OFFICE OF
FRESNO
IRRIGATION DISTRICT

May 16, 2012

RE: Review of 30% High Speed Rail Plans for Segment 1A
(Veteran's Boulevard to Stanislaus Street)

FID Facilities: Herndon Canal No. 39 Lisenby No. 45, Victoria No. 42, Victoria Colony No. 43, Tracy No. 44, Cole West Branch No. 40, Cole South Branch No. 40, and Dry Creek No. 75.

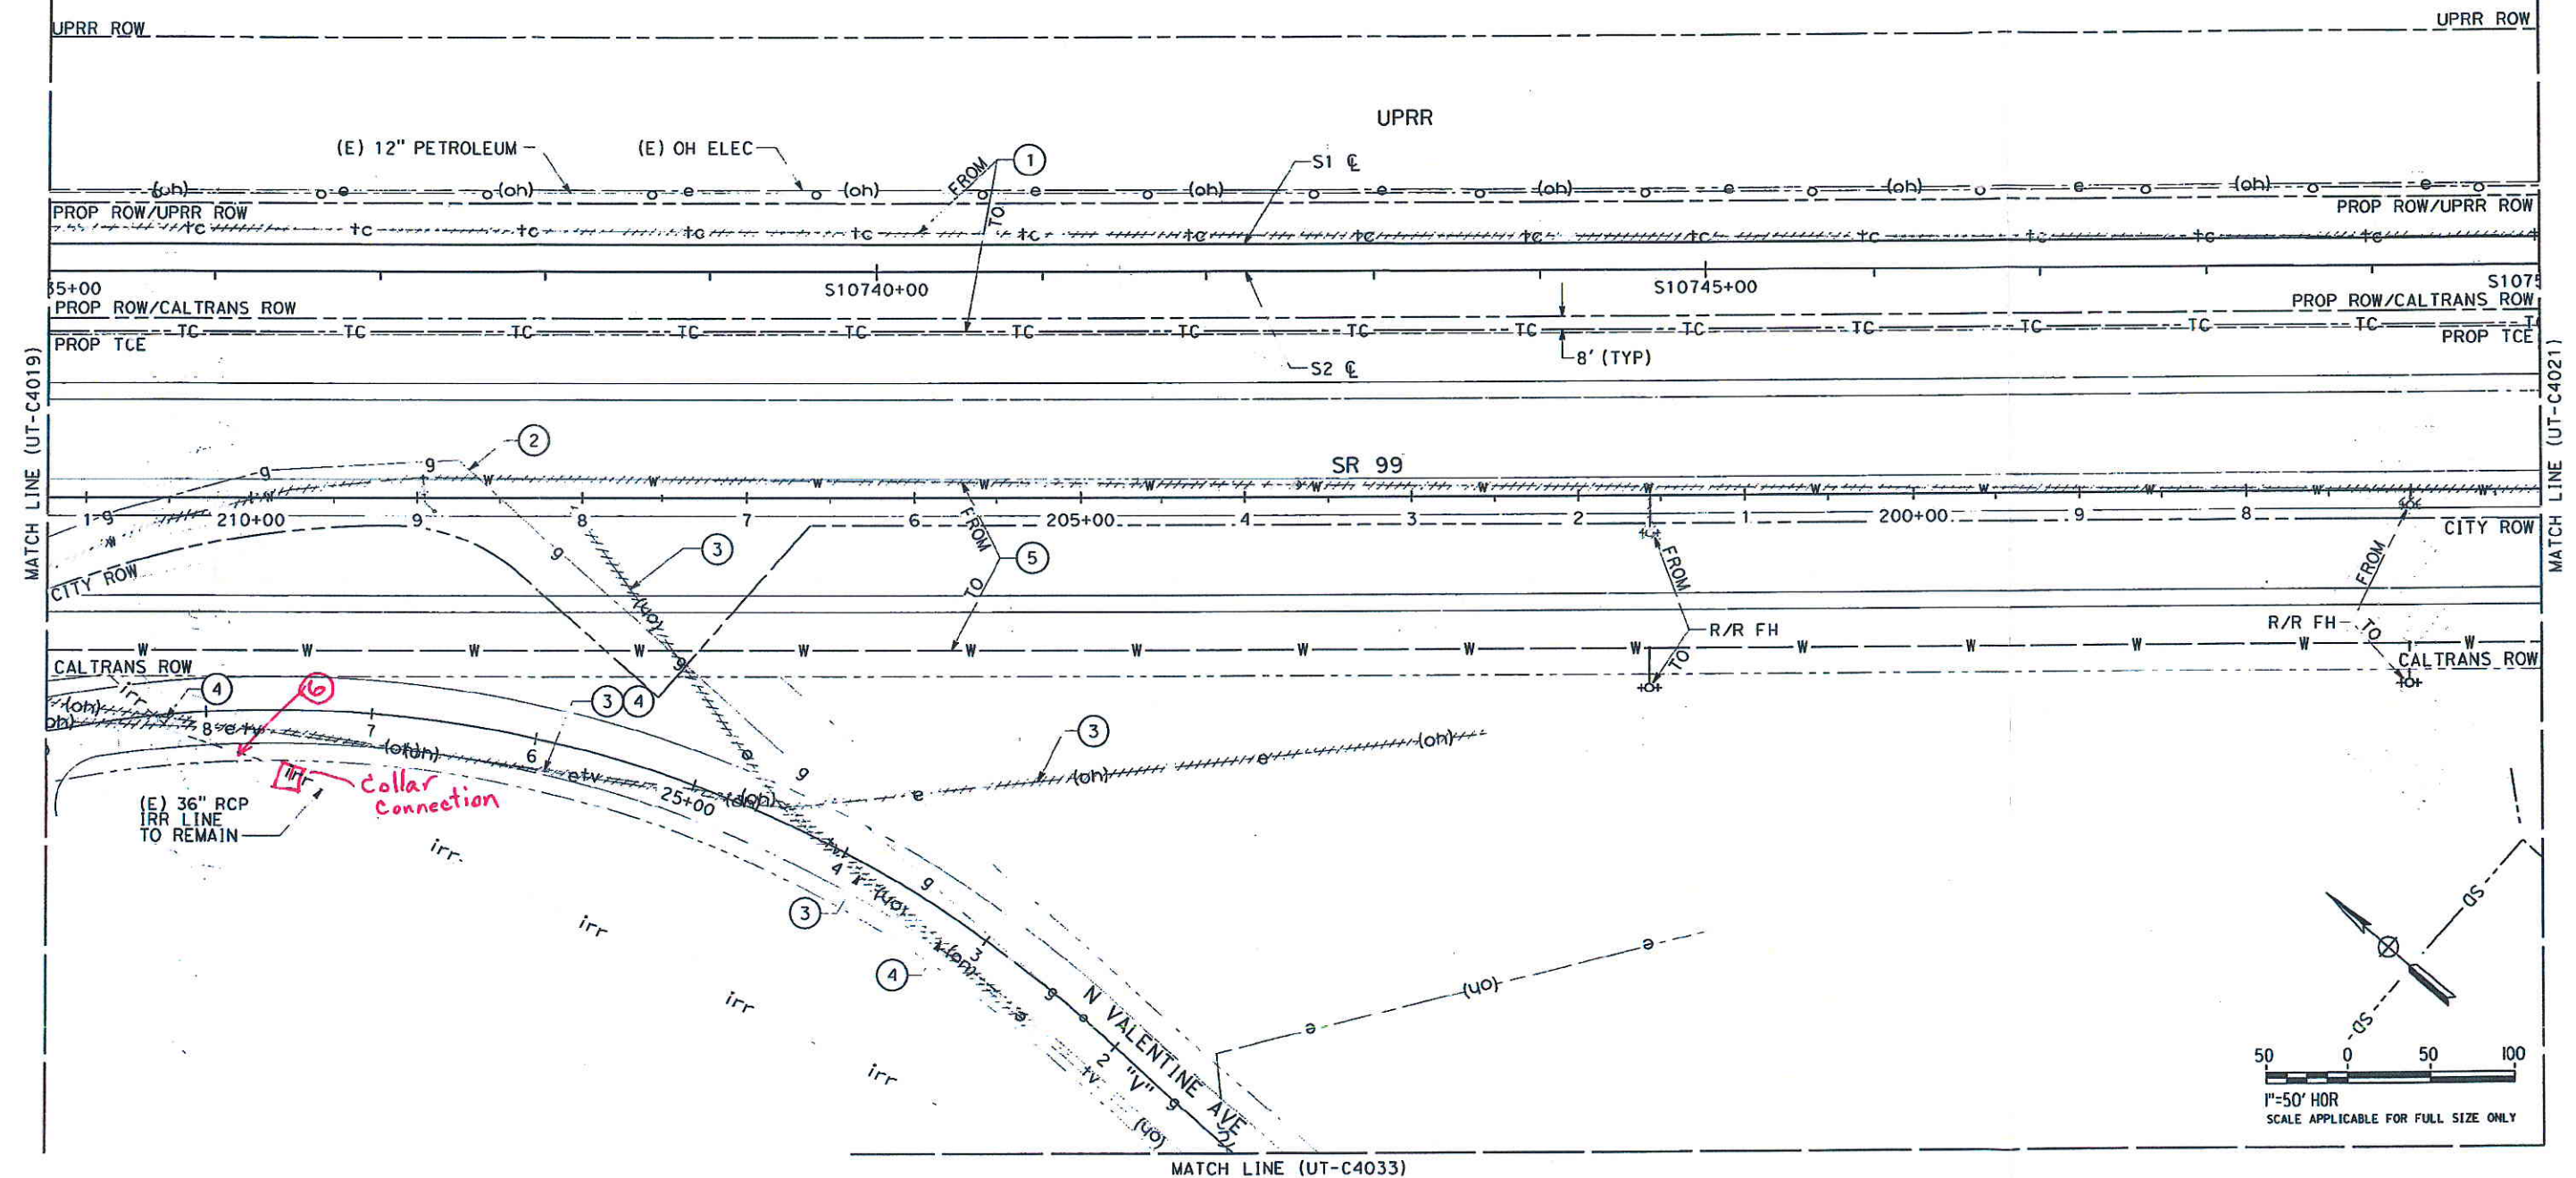
- Add the name of FID's facility to all appropriate plan sheets, including the Utility Information tables on the Utilities sheets.
- Plan sheets reviewed include CV-R1009-R99, CV-G1010-R99, CV-G1009-R99, CV-G1017-R99, CV-G1007, CV-R1017-R99, UT-C4019, UT-C4020, C4033. Please identify any other sheets that cover the area of this FID facility.
